The Legacy Way project (formerly known as Northern Link Road Tunnel)

## **Coordinator-General's report on a project change**

June 2011

Figure 1.1 Proposed construction workforce parking area: Park and Ride car park

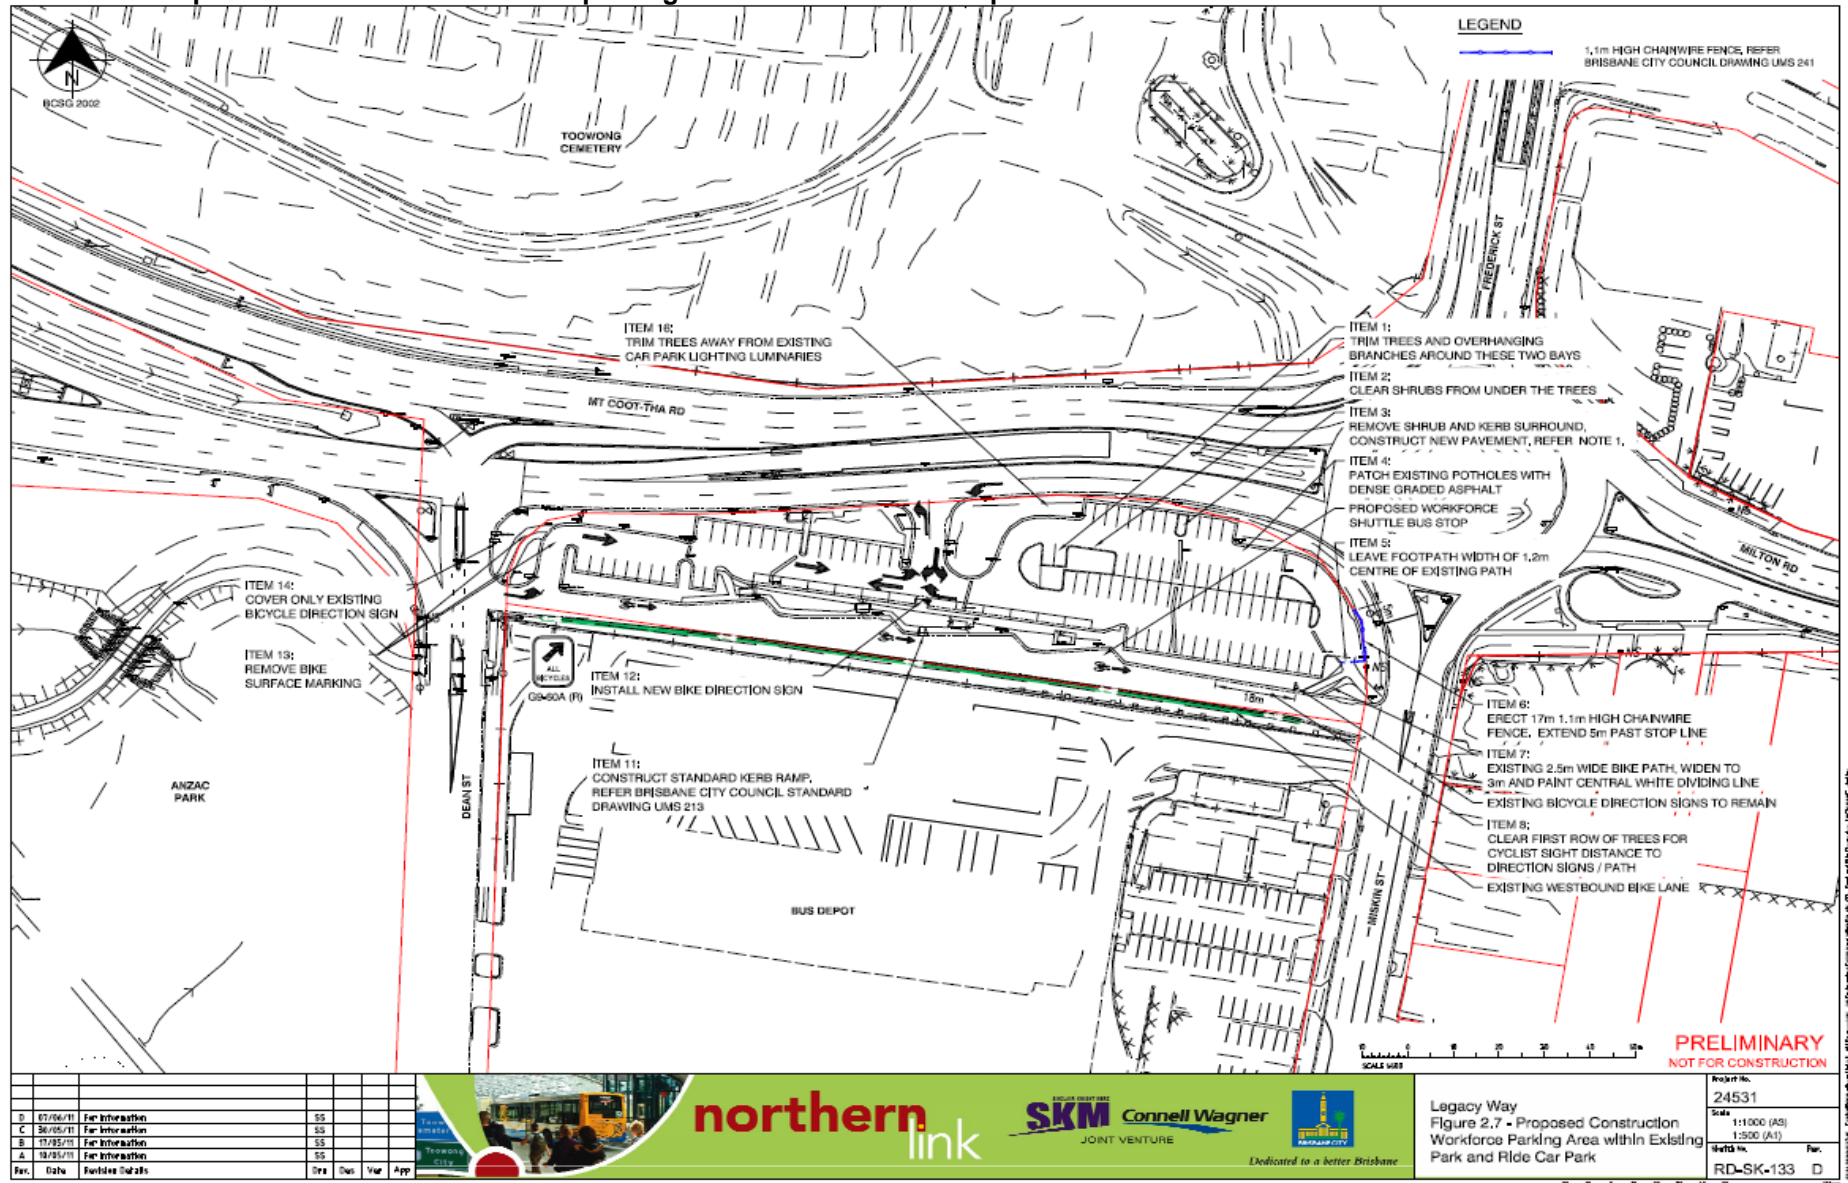
In terms of access, the APC describes vehicles would be able to enter the car park directly from Mount Coot-tha Road for vehicles travelling out-bound from the city, or from the western suburbs (see Figure 1.1). There is no right turn into the Park and Ride should vehicles approach along Dean Street, therefore access to the site is focused to be from Mount Coot-tha Road. Access as a left turn from Mount Coot-tha Road on to Dean Street and then an immediate left turn into the site also exists.

Submitters raised concerns with cyclists travelling in the vicinity of the Park and Ride. Figure 1.1 describes the current signage and line markings for cyclist use in the area.

Cyclists can currently cycle in both directions between Dean Street and Miskin Street either through the Park and Ride or along the dedicated bus route adjacent to the car park (refer to Figure 1.1). BQ advised that the majority of cyclists used the bus lane for inbound travel, and the contraflow bike lane on the bus depot boundary for outbound travel.

To ensure the safety of cyclists, the APC proposes to discourage cyclists from using the through-car-park route and only use the bus route. Pedestrians would however be able to exit through the car park onto Miskin Street. The APC states BQ has confirmed that the loss of the alignment through the car park would not be a significant issue, providing the signs and markings were changed to reflect the changed condition.

- install a barrier (for example, fencing) on the existing bicycle/pedestrian path at the eastern end of the park, to prevent vehicles from using the bicycle path to exit the car park on to Miskin Street, which currently occurs

- improve the existing lighting in the area, by trimming trees and shrubs affecting light distribution and visibility, and maintaining existing lights
- increase the width of the bike path that runs adjacent to the Park and Ride from 2.5 metres to 3 metres and install signage and line-mark the area as a dual-way path. Provision would also be made for cyclists to be able to exit onto the bus way lane near the current bus stop

- temporarily remove existing signs directing cyclists towards the car park route. Should cyclists use the car park route, they will be directed by new signage to the bus route option via an existing pathway from the car park

- modify the kerb at the entrance to the bus route, at the end of the path, to provide for cyclist use.

Figure 1.1 details the proposed changes to the area to address safety and co-use. The APC states these measures were agreed with BQ.

- (a) The proponent is required to undertake improvements to the Park and Ride area for the safety of pedestrians and cyclists using the area or travelling in the vicinity of it. These are to include installing signage and fencing, modifying existing kerbing and line-markings, and improving lighting as described in Figure 1.1 of *The Legacy Way project (formerly known as Northern Link Road Tunnel): Coordinator-General's report on a project change* (June 2011).
- (b) Written confirmation that the amendments have been made to the area is to be provided to the Coordinator-General within two weeks of completion, or by 31 August 2011, whichever is sooner.
